October 8, 2020

RE: Mid-Peninsula Housing Parking Structure Modifications

PREVIOUS CORNER SKETCH

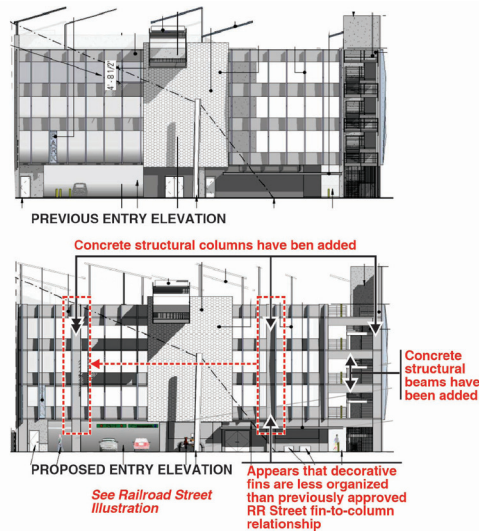
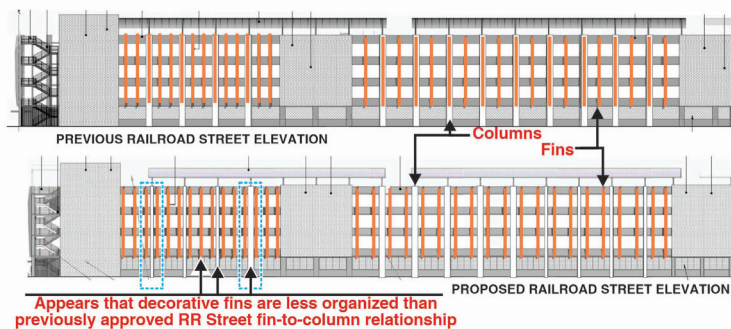
1. While the changes to the structural system would change the appearance of the corner pedestrian exit stair, that change should not be detrimental to the appearance of the structure. However the addition of the exterior columns has created some issues with coordinating the placement of the decorative fins relative to the exterior columns. On the previous design, the exterior columns and fins were aligned in a well organized manner. The fin-to-column relationship on the revised Railroad Street and Fifth Avenue elevations, however, may not be as attractive. The fins aligned with the columns on the previous design provided a uniform pattern which masked the concrete structural framework which served to diminish the appearance of a large concrete structure. The revised pattern where the fins straddle the columns will make the underlying structure more dominant. There may always be an architectural argument about whether a garage should express itself as a garage or be expressed as a more sculptural form, but the thrust of my earlier recommendations was to diminish the underlying structure.

My only recommendation is to recommend that staff discuss this issue with the applicant, and decide if changes could be made to bring the design appearance more in line with the approved parking garage design.
